ADDENDUM TWO

Southwest Allen County Schools - 2025 Roofing and Related Work at Haverhill Elementary School
4725 Weatherside Run
Fort Wayne, IN 46804

Commission No.: F24093
Addendum Date: 2025.03.24

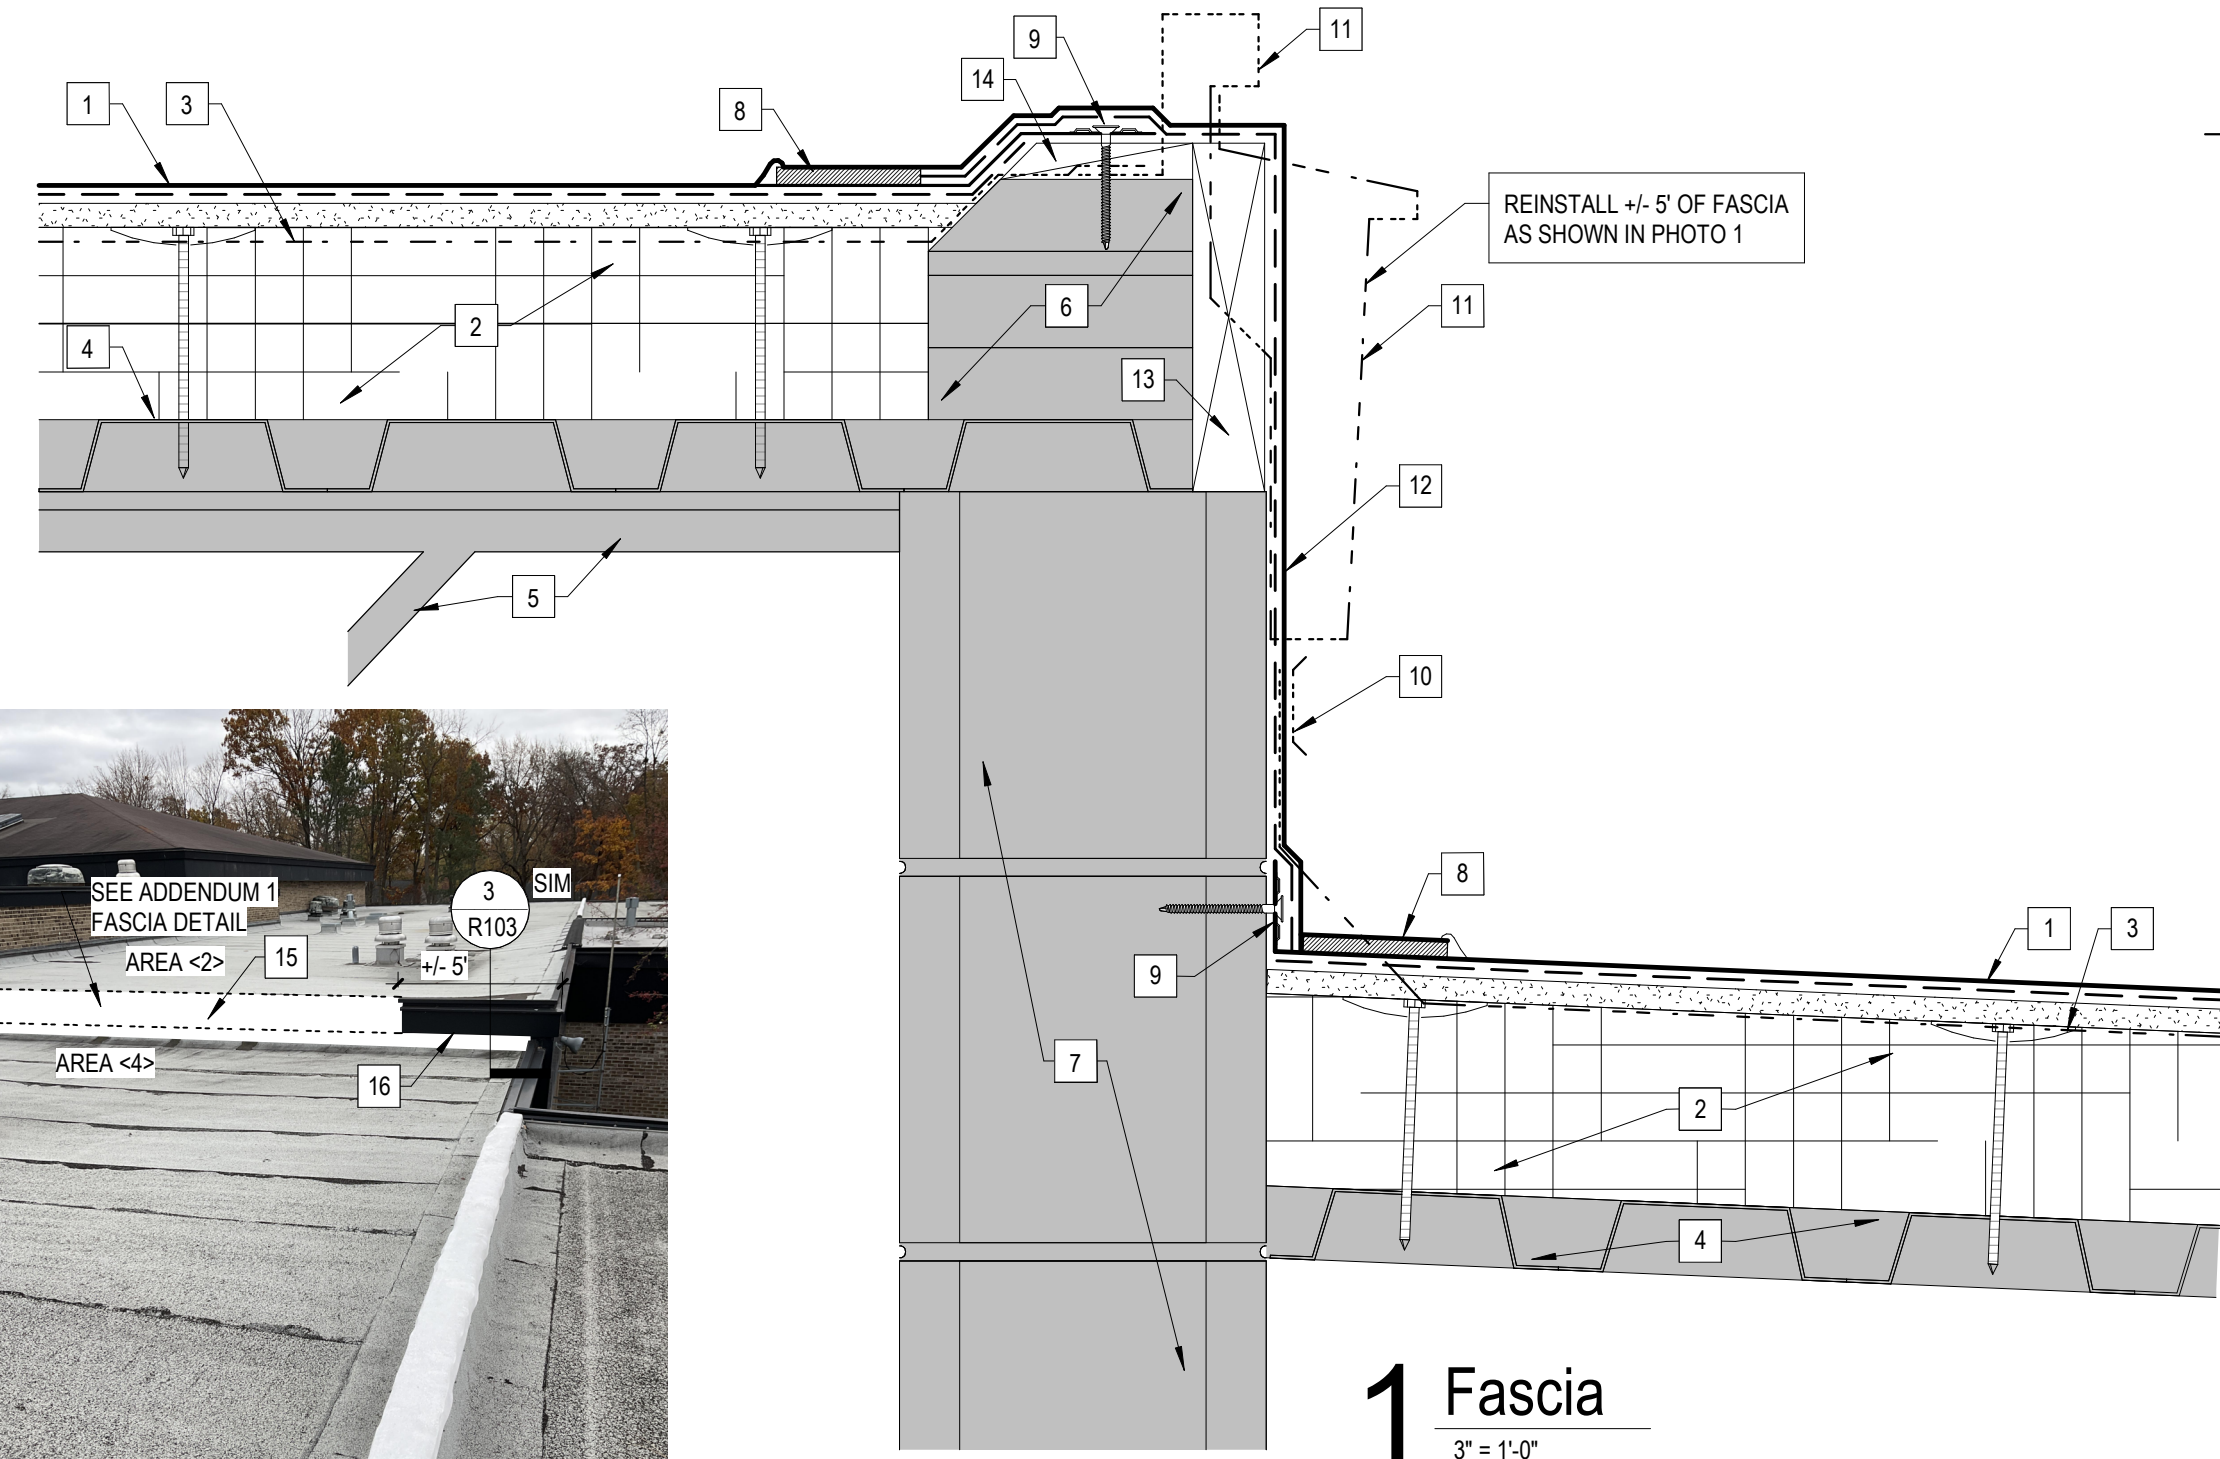
Sheet R102 - PARTIAL ROOF PLAN - PLAN WORK DESCRIPTION BASE WORK R102 - NOTE 15 - **REPLACE WITH** - "EXG SMOKE HATCHES (SH) AND AIR INTAKE (AI) BASE FLASHING HEIGHT TO REMAIN. PROVIDE NEW STEP FLASHING AND GI COUNTER FLASHING - MECHANICALLY ATTACHED TO EQUIPMENT HOOD FLANGE AT 12" C/C MAXIMUM. NOTE SMOKE HATCHES ARE RUNNING PARALLEL TO THE ROOF SLOPE AND TYPICAL STEP FLASHING AND CRICKET DETAILS WILL NEED ADJUSTED ACCOURDINGLY, AREA <1> - SEE DETAILS 6/R106, 7R106 AND 8/R106".

1 Fascia
3" = 1'-0"

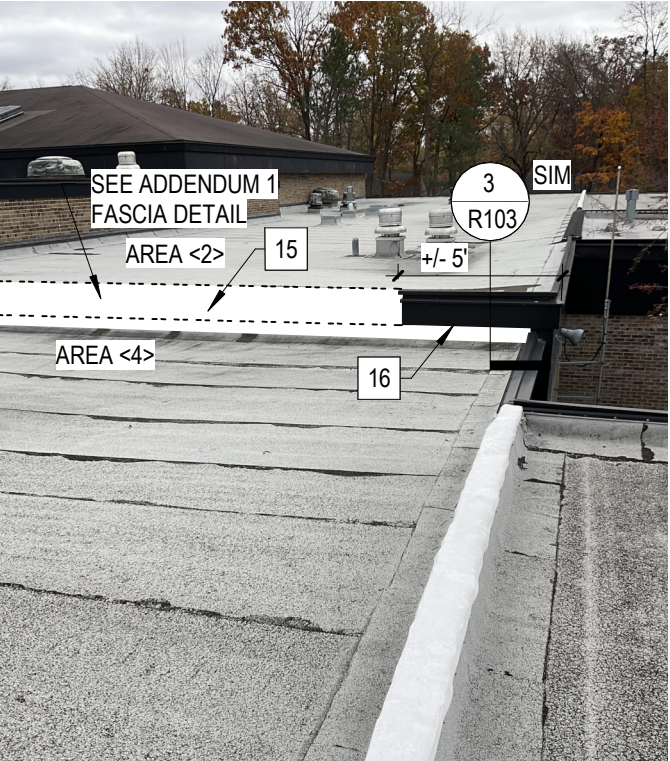
- 1 NEW IPA-FLEXIBLE SHEET ROOFING (FSR)
- 2 NEW (2) LAYERS OF 2" MECHANICALLY ATTACHED RIGID INSULATION BOARD AND 1/2" COVERBOARD
- 3 REMOVE EXISTING MBR ROOFING, COVERBOARD, INSULATION, SADDLES, FLASHINGS (FLG) CANTS AND STRIPPINGS

- 4 EXG 1 1/2 METAL B-DECK TO REMAIN. INSPECT DECK FOR DAMAGE OR DETERIORATION AND REPORT CONDITIONS TO ROOF CONSULTANT
- 5 EXG STRUCTURE TO REMAIN
- 6 EXG WOOD BLOCKING TO REMAIN. REPLACE ANY DAMAGED OR DETERIORATED WOOD BLOCKING WITH NEW WOOD BLOCKING

- 7 EXG MASONRY WALL TO REMAIN
- 8 NEW HOT AIR WELD JOINT WITH TOOLED MANUFACTURER RECOMMENDED SEALANT
- 9 NEW FLEXIBLE SHEET ROOFING SEAM PLATE 12" C/C MAX

- 10 REMOVE EXG TERMINATION BAR
- 11 REMOVE EXG FASCIA SYSTEM
- 12 CLEAN SUBSTRATE, PROVIDE NEW FULLY ADHERED FLEXIBLE SHEET ROOFING (FSR) FLASHING
- 13 NEW WOOD BLOCKING MECHANICALLY ATTACHED TO SUBSTRATE

- 14 NEW WOOD BLOCKING MECHANICALLY ATTACHED TO SUBSTRATE. BEVEL EDGE TO MATCH EXG BLOCKING
- 15 REMOVE EXG FASCIA SYSTEM, ADD BLOCKING AND RUN FSR UP AND OVER EXG STRUCTURE PER ADDENDUM 1 FASCIA DETAIL

- 16 REMOVE, SALVAGE AND REINSTALL +/-5' (TO EXG SPLICE JOINT) OF LOWER FASCIA AFTER FSR IS RAN UP AND OVER EXG STRUCTURE - SEE SIM DETAIL 3/R103
